**SUBJECT: REVISION "B" TO TECHNICAL BULLETIN 212-78-15:
REPAIR OF ENGINE SERVICE DECK CENTER PANEL P/N 212-
030-009-007 AND -097**

No. 212-78-15

SUBJECT: REPAIR OF ENGINE SERVICE DECK CENTER
PANEL P/N 212-030-009-007 AND -097

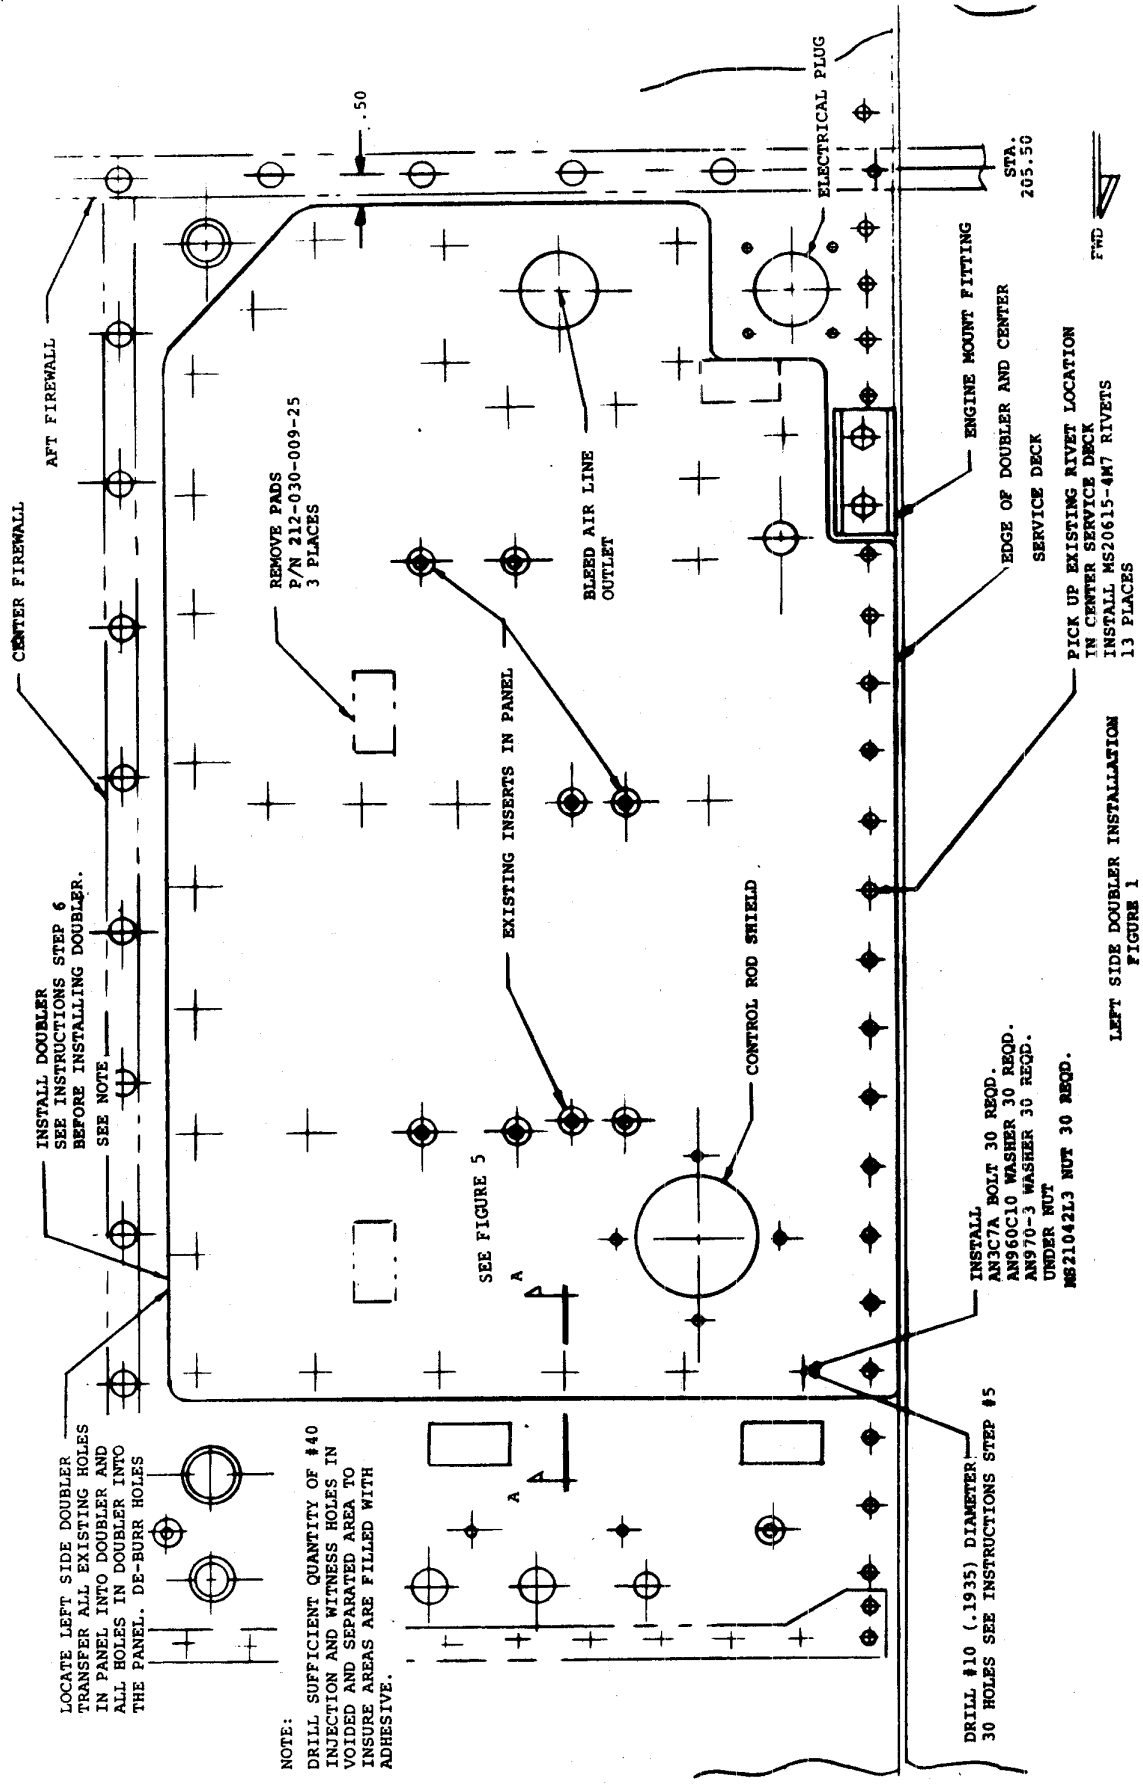
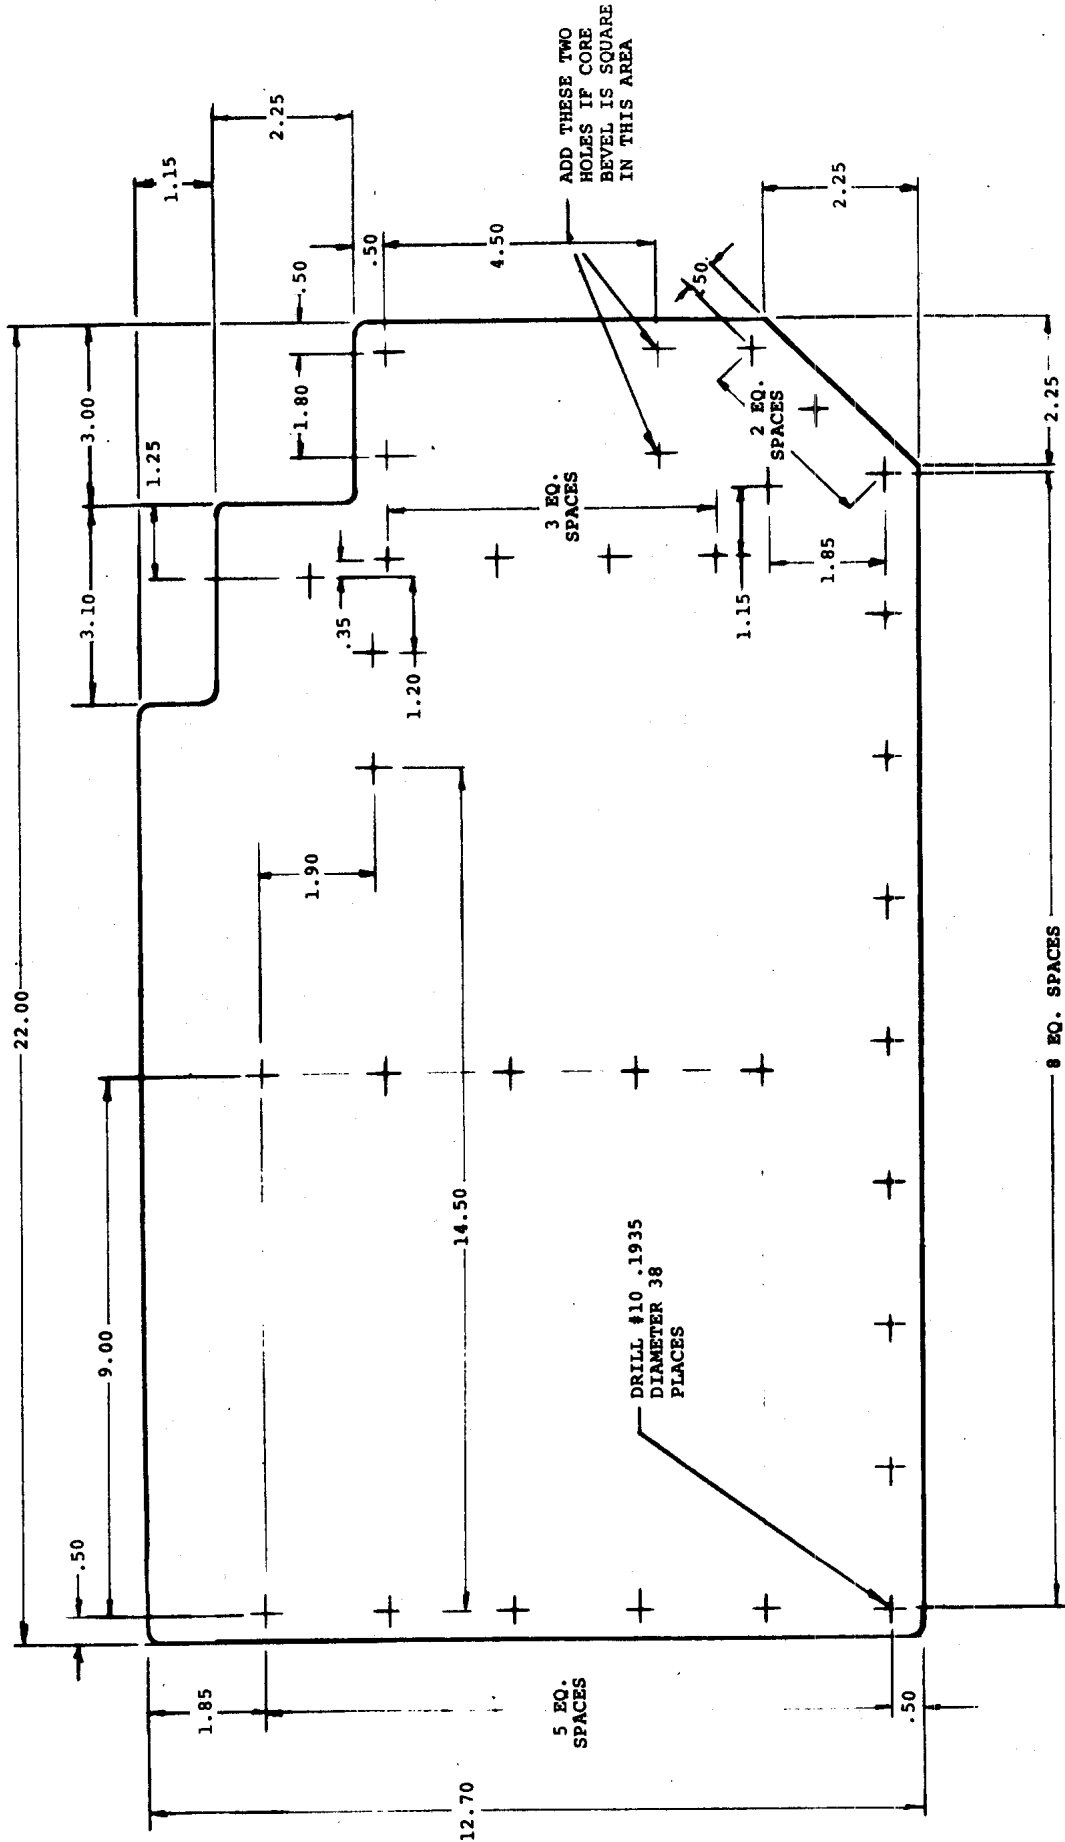
3. Refer to Figure 3 and 4. Fabricate the two doublers as detailed from 0.040"-thick 301, ¼ hard stainless steel.
4. Refer to Figure 1 and 2. Locate the doublers and drill holes in the panel from the doublers and pick-up existing holes in the panel into the doublers. Use sharp cobalt drills.

Fill the void or delaminated area with adhesive prior to installing the doubler. Install the doublers, refer to Figure 1 and 2. Clean excessive adhesive from the panel and doublers. Apply a bead of Proseal 700 around the edges of the doublers.
